SAFETY EVALUATION REPORT
REVIEW OF APPLICATION TO AMEND LICENSE CONDITION 11.3(C), LICENSE SUA-1601,
STRATA ENERGY, INC. ROSS IN SITU RECOVERY FACILITY, CROOK COUNTY, WY

DATE: January, 2018

DOCKET NO.: 040-09091

TECHNICAL REVIEWER: John L. Saxton

Figure 1. Well Yields of 0.5 GPM as a Function of Available Water Column, Transmissivity and Storativity

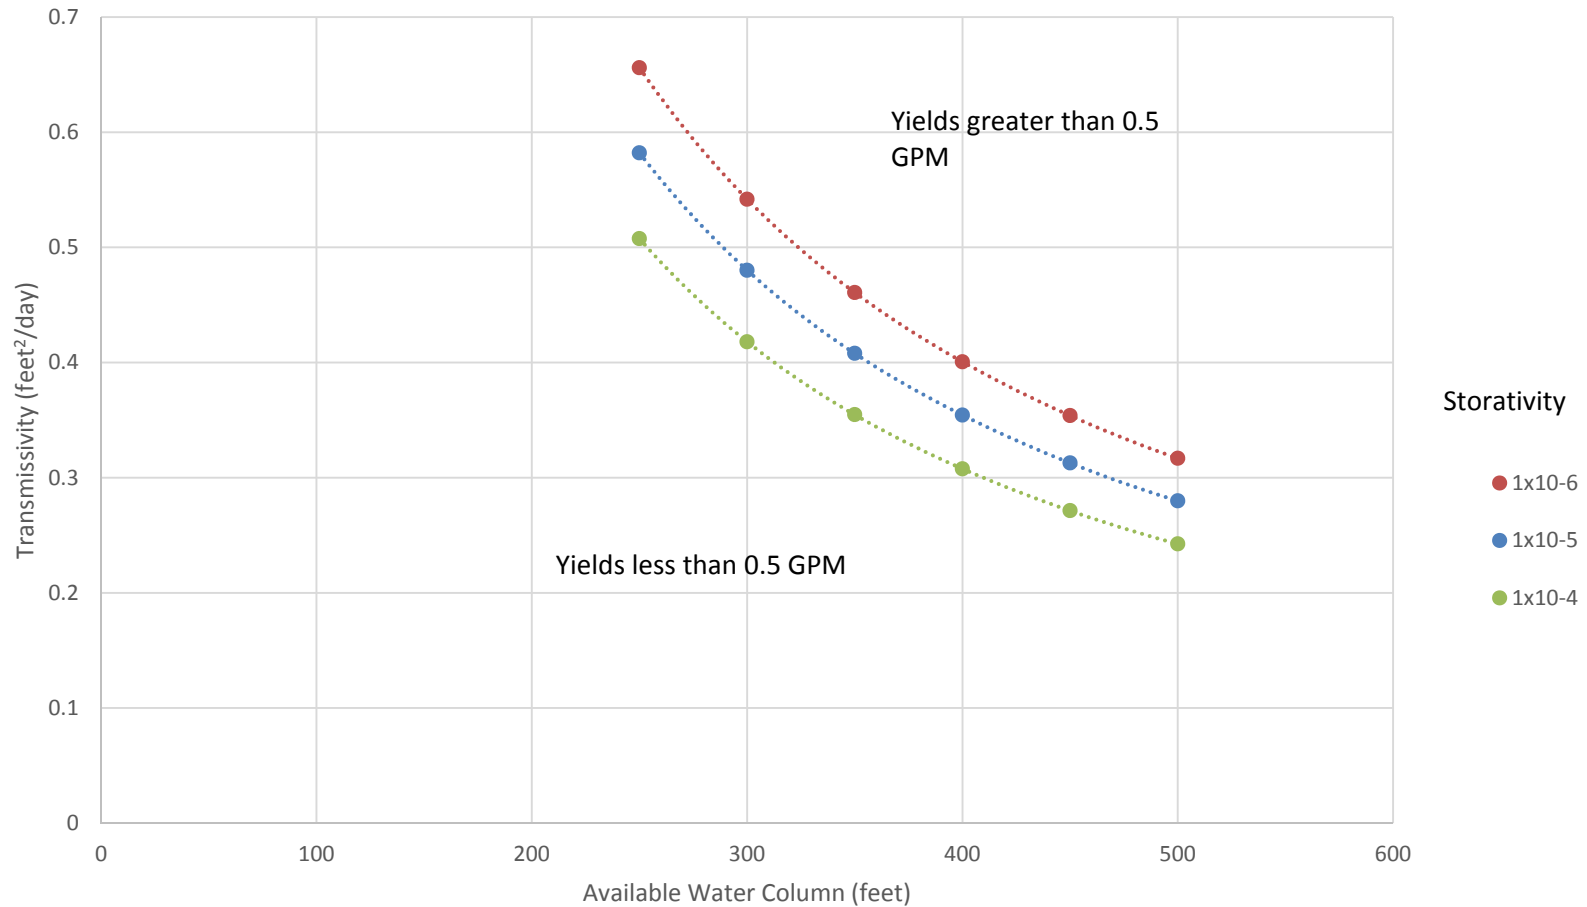
The NRC staff finds Strata's proposed criterion 5 acceptable because it is based on established State of Wyoming criteria. Furthermore, staff find the procedures used by Strata acceptable (with one caveat listed below) because they quantify a sustainable yield for a specific well based on (1) estimates of the hydraulic properties for the aquifer in the vicinity of the well using established slug testing methodology, (2) an appropriate period for sustainable pumping, (3) utilizing actual water column in the pumping well available for cumulative drawdown, and (4) established models for non-equilibrium radial flow to a well. The assumed parameters for Strata's analysis include storativity of the aquifer (1×10^{-5}), estimated available water column with a factor of safety (20 feet above the pump intake which is 30 feet above the top of the screened horizon) and the pumping duration (365 days). The measured parameters for Strata's analysis include radius of the well screen (0.4375 feet), radius of the well casing (0.1875 feet), aquifer thickness (13 to 25 feet), available water column (static water elevation minus the maximum safe drawdown elevation) (205.8 to 493.9 feet) (Strata, 2017c). The calculated parameters for Strata's analysis include transmissivity of the aquifer and well yield. The NRC Staff finds that the assumed and measured parameters are appropriate and confirmed that Strata's calculations for the well yield are correct using Strata's assumed, measured and calculated parameters (Table 1).

Figure 2. Examples of Curve Fitting to Strata’s Data and Estimation of Time to 0.25 Recovery

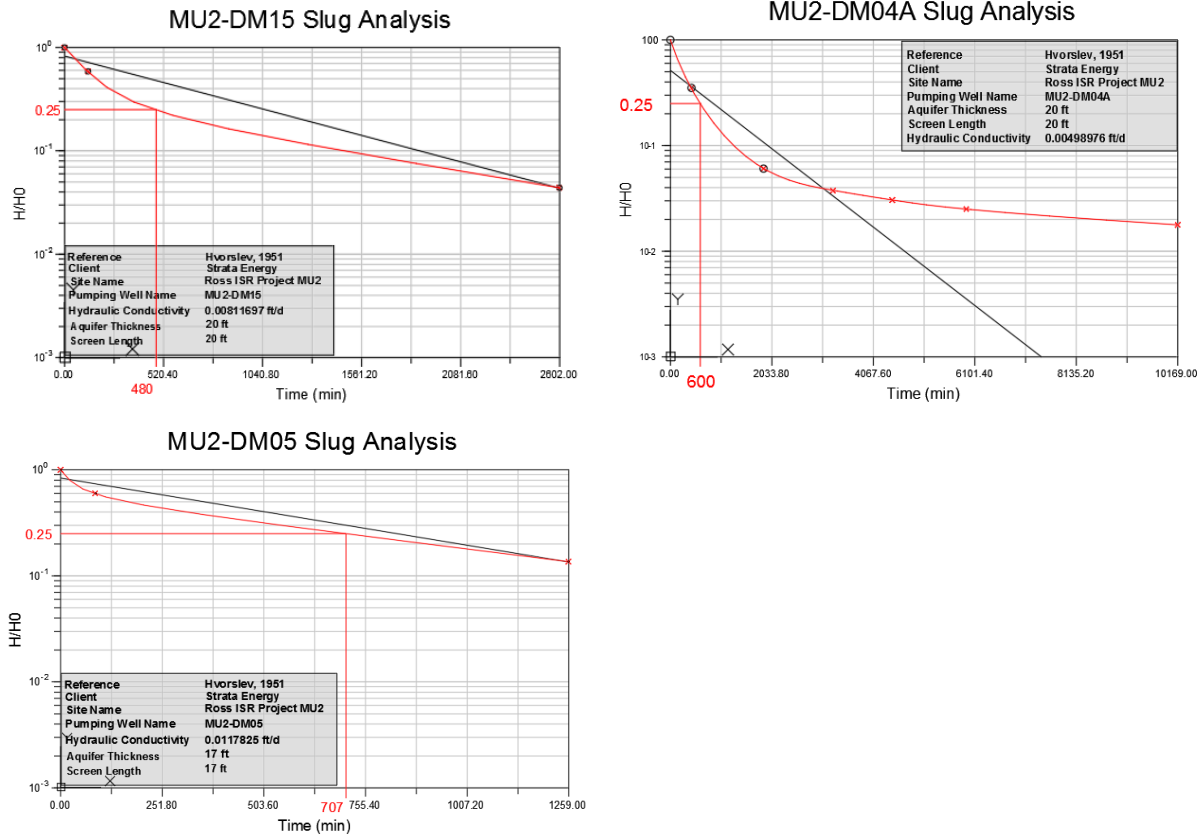
To establish whether Strata's proposal to eliminate any wells from monitoring was based on a flawed analysis, the NRC staff verified Strata's calculations by using the Cooper and Papadopulos methods to establish a transmissivity. The method typically consists of fitting the observed data to a model type curve and then establish a match point between the observed time and dimensionless time for the model curve (Dawson and Istok, 1991; Fetter, 1980). Because of the limited data, the NRC staff used a variant of the method by obtaining a match point for a selected normalized head. In this case, the NRC staff used a normalized head that was 25 percent of the initial head. To establish the normalized 25 percent head, curves were fitted to the data using Strata's graphs from the mine unit reports (for examples, see Figure 2).

The NRC staff determined that the data for wells MU2-DM01, MU2-DM05 and MU2-DM15 was insufficient or had sufficient uncertainty that the verification was deemed unnecessary and the wells were included in any proposed monitoring program. For the remainder of wells, the NRC staff estimated the time to the 25 percent normalized head varied between 0.2 and 13.7 days (Table 2).

Figure 4. Mine Unit 1 and 2 Wells exceeding the Yield Criterion

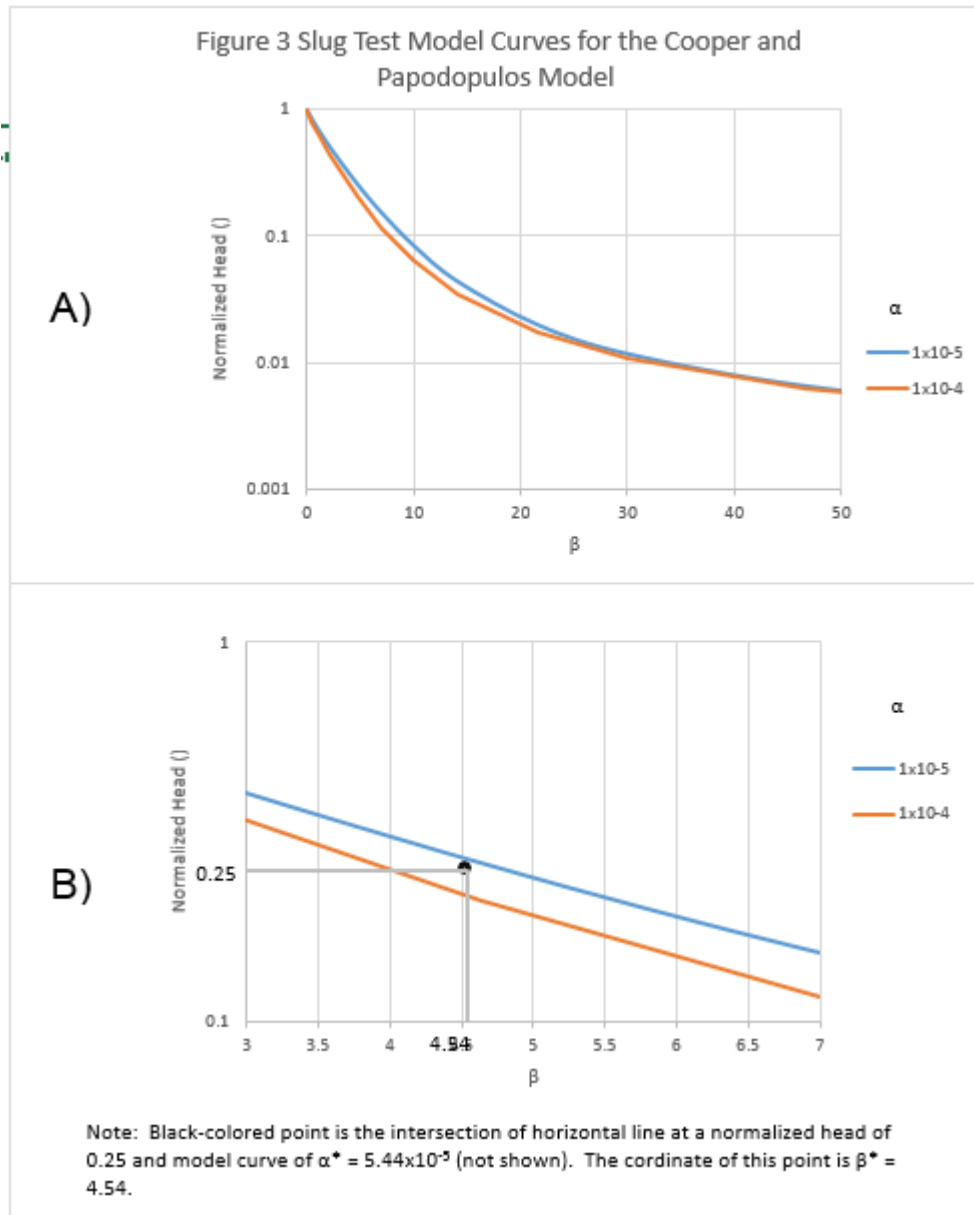
The calculated transmissivities through the verification process varied from 0.01 to 1.28 square feet per day (Table 2). Using the estimate of transmissivity developed through the verification process, a safe yield was determined for each well using the method described above (Table 2). The NRC staff's estimate of the transmissivity during the verification process was consistent with Strata's calculations (within 0.05 square feet per day) for all wells in Mine Unit 1 and wells MU2-DM02, MU2-DM11, MU2-DM14, MU2-DM16 and MU2-DM19. For wells MU2-DM04a, MU2-DM12a, MU2-DM17, MU2-DM18, MU2-DM20 and MU2-DM21, staff's verification transmissivity differed from Strata's calculation (greater than 0.05 square feet per day) but did not result in a predicted well yield greater than 0.5 gpm. For those wells, staff finds that that Strata's conclusions are valid (Figure 4). For wells MU2-DM-06, MU2-DM-08, MU2-DM-09, MU2-DM-22 and MU2-DM-23, staff's verification transmissivity resulted in a predicted well yield greater than 0.5 gpm and thus did not verify Strata's calculations.

Therefore, the NRC staff finds that all DM unit wells in Mine Unit 1, and the DM unit wells in Mine Unit 2 except wells MU2-DM01, MU2-DM-05, MU2-DM-06, MU2-DM-08, MU2-DM-09, MU2-DM15, MU2-DM-22 and MU2-DM-23, have a predicted yield less than WDEQ/LQD criterion of 0.5 gpm and recommends those wells be removed from the monitoring program as requested by Strata. Staff finds that predicted well yields for wells MU2-DM01, MU2-DM-05, MU2-DM-06, MU2-DM-08, MU2-DM-09, MU2-DM15, MU2-DM-22 and MU2-DM-23 cannot be verified and thus continued monitoring is required (i.e., Strata's request is denied for these wells). Strata may elect to re-perform slug tests at the wells that yield insufficient data and resubmit a request for staff to evaluate the new data in the future.

- Mine Unit 1: Monitoring at all wells is discontinued.
- Mine Unit 2: Monitoring is required at wells MU2-DM01, MU2-DM05, MU2-DM06, MU2-DM08, MU2-DM09, MU2-DM15, MU2-DM22 and MU2-DM23
